ADDENDUM #3

THE WICHITA AIRPORT AUTHORITY
COLONEL JAMES JABARA AIRPORT

ELECTRICAL SITE PLAN

SANITARY SEWER AND WATER DISTRIBUTION SYSTEM
SOUTHWEST AREA SITE DEVELOPMENT IMPROVEMENTS

A ELECTRICAL SITE PLAN
SCALE: 1" = 40'-0"

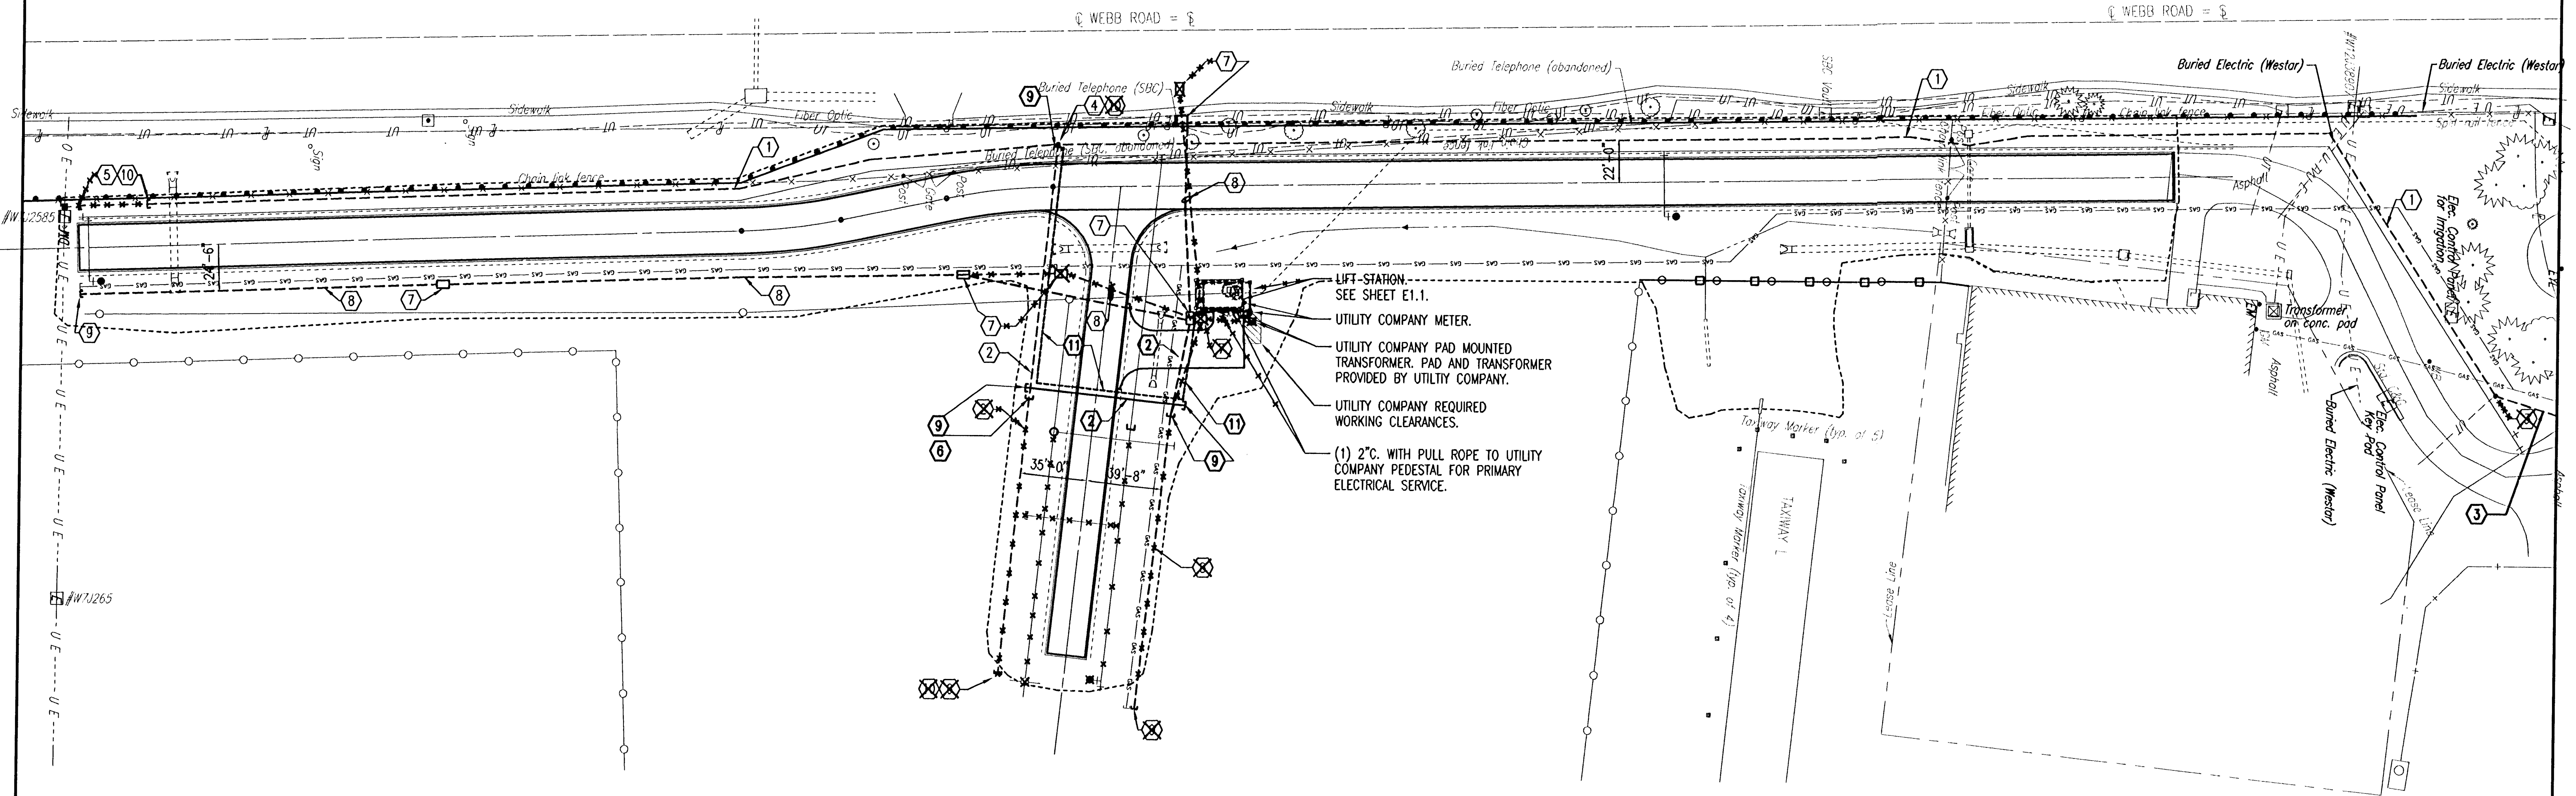
ADD. #3 (CORRECTED ADD. #3 FROM NOTE 3 TO NOTE 4)
TELEPHONE CABLES SHALL BE CATEGORY 3, GEL FILLED, DIRECT BURIED, 22 AWG, GOPHER PROOF OUTSIDE PLANT RATED.
